PLAN COMMISSION STAFF REPORT

Agenda Item: PC Docket No. 22-016

Summary: Centennial Village LLC requesting approval of a development plan for Building F of the Centennial Village Planned Unit Development at 9600 North Centennial Drive.

Centennial Village Bldg. F
Munster, Indiana
SITE PLAN

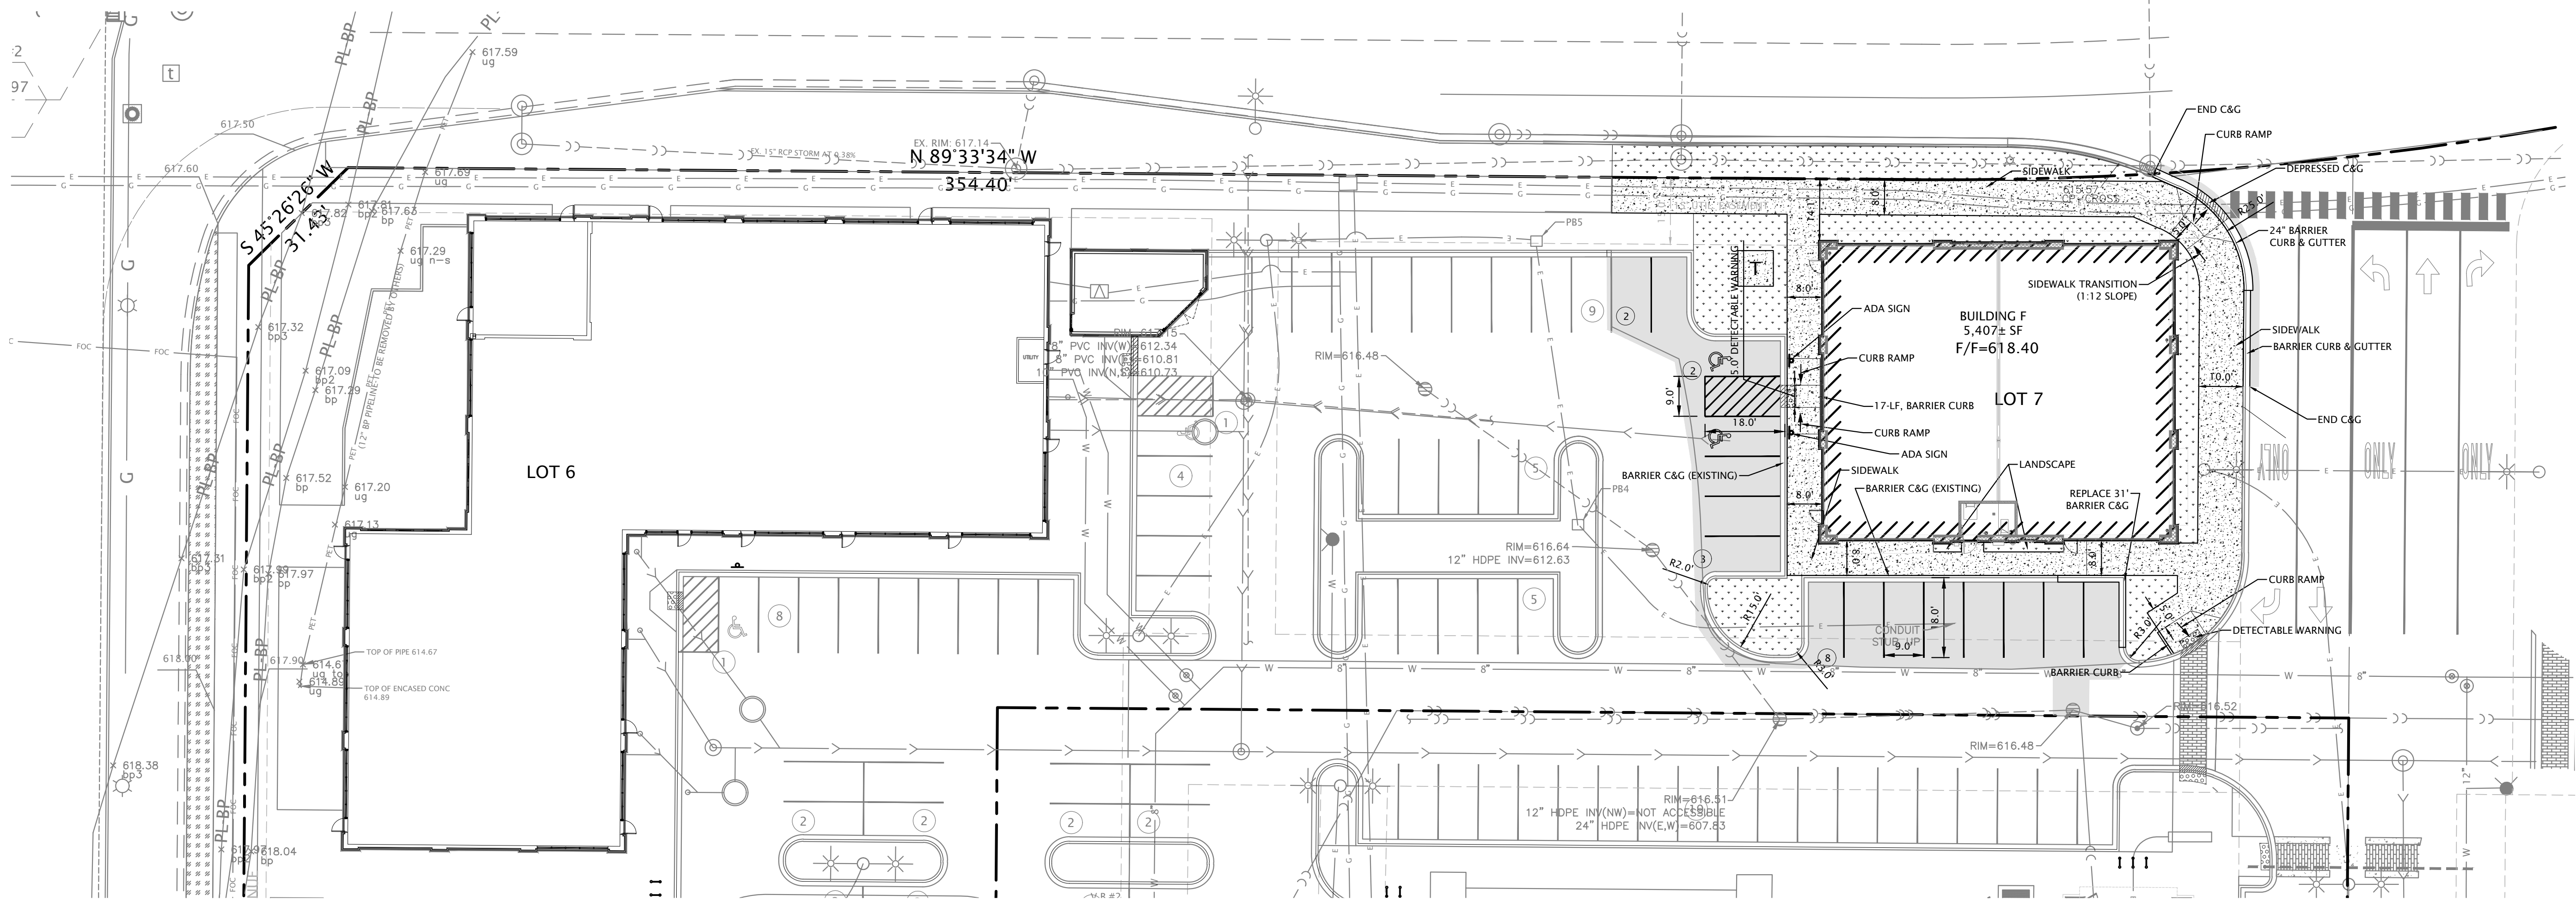
Building F encroaches 1.3' into a 15' utility easement that runs along the north edge of the property. The applicant is in discussion with NIPSCO either to reduce the width of the easement or to permit the encroachment, but that approval has not been made at this time.

In addition to the site work, the curb radius will be adjusted at the southeast corner of 45th and North Centennial Drive to allow for the required 10' sidewalk to the east of Building F.

1. The applicant receive approval from NIPSCO to reduce the width of the 15' easement that runs along the north side of the subject property or to encroach onto the easement.
2. A revised landscaping plan be submitted using the approved site plan and including the required parkway trees.
3. Final engineering review.

Centennial Village Bldg. F
Munster, Indiana
LIGHTING, POWER & TELECOM PLAN

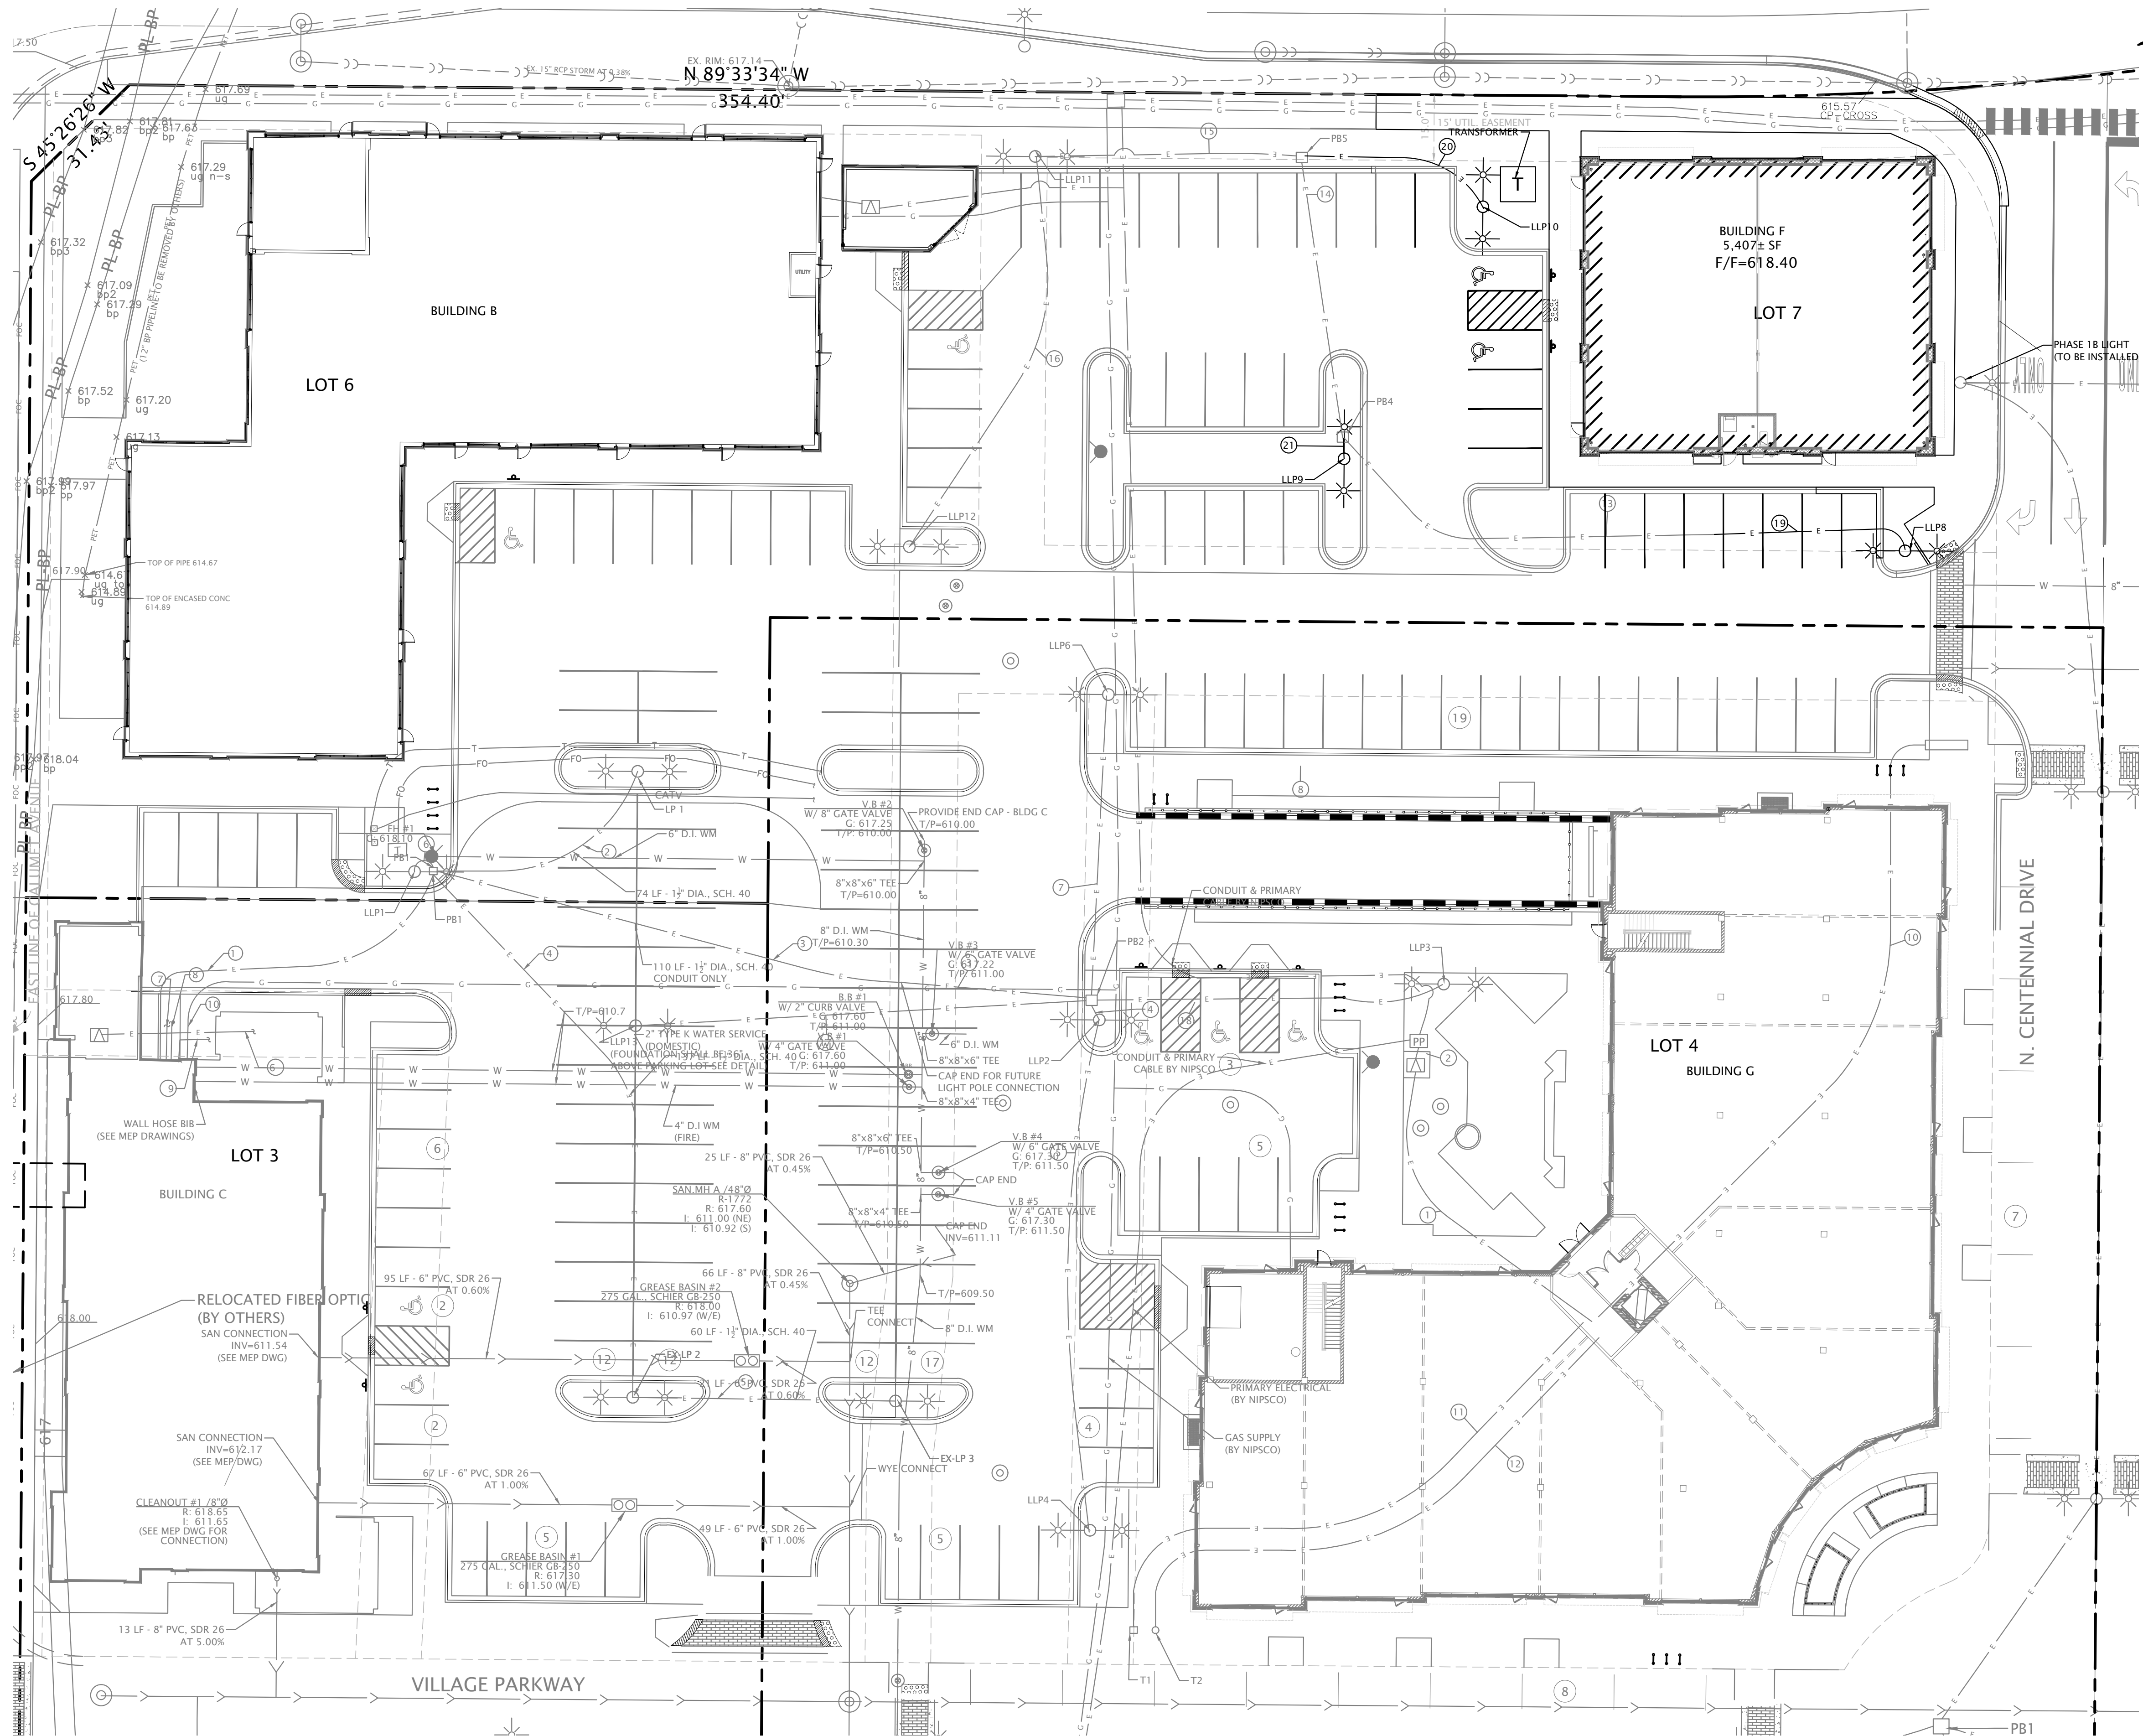
A photometric plan and details of the light fixtures have been provided for review. The Lighting, Power, & Telecom Plan specifies that 20-5" tall streetlights will be installed throughout the parking lot. The building renderings indicate that sconces will be installed on the building, but we have not been provided the cut sheets.

The approved design standards require a minimum illumination of 0.5 foot candles at the lot line and the illumination of all other areas to be between 3 and 10 foot candles. An updated photometric plan has not been submitted.

Staff recommends any approvals be made contingent upon staff approval of a photometric plan that meets the approved design standards.

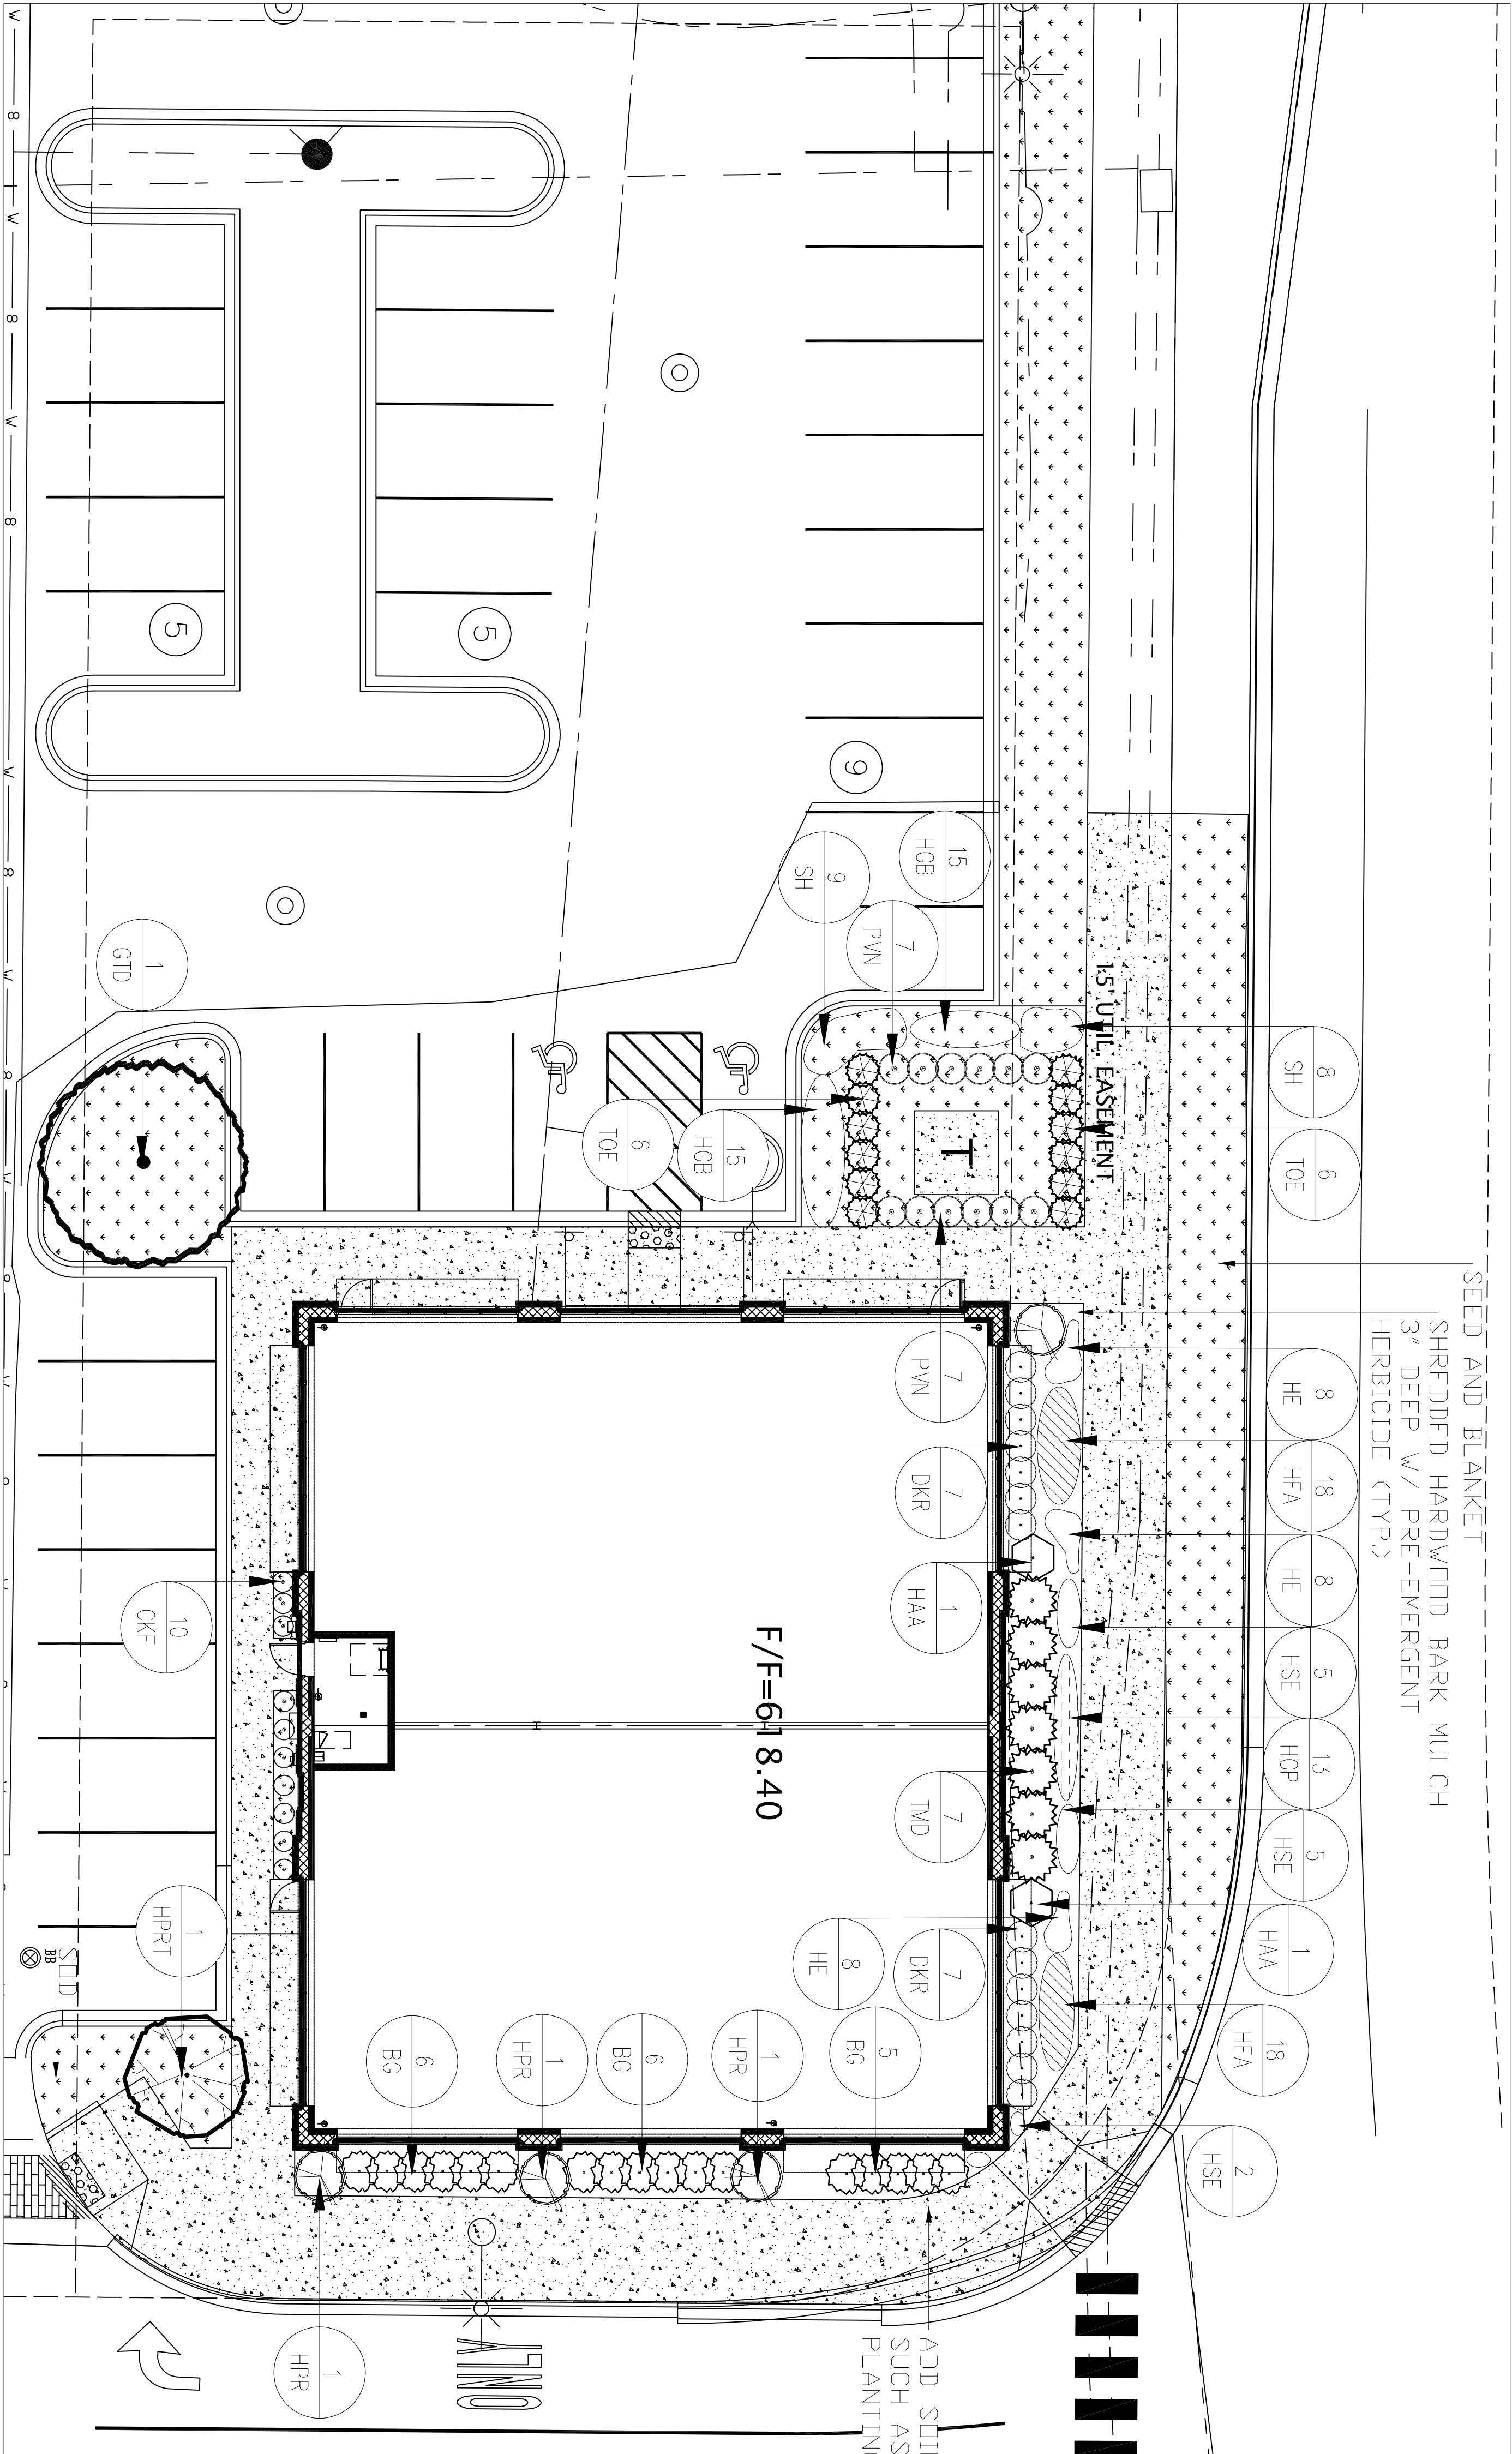
A landscaping plan is provided, but it is based on a previous version of the site plan. The plan includes foundation plantings on the street facing sides of the building. Staff recommends the following revisions:

- Add street trees along street frontages on the north and east, planted at 30' spacing, in keeping with the Munster Landscaping Ordinance.
- Provide irrigation for all landscaping areas.
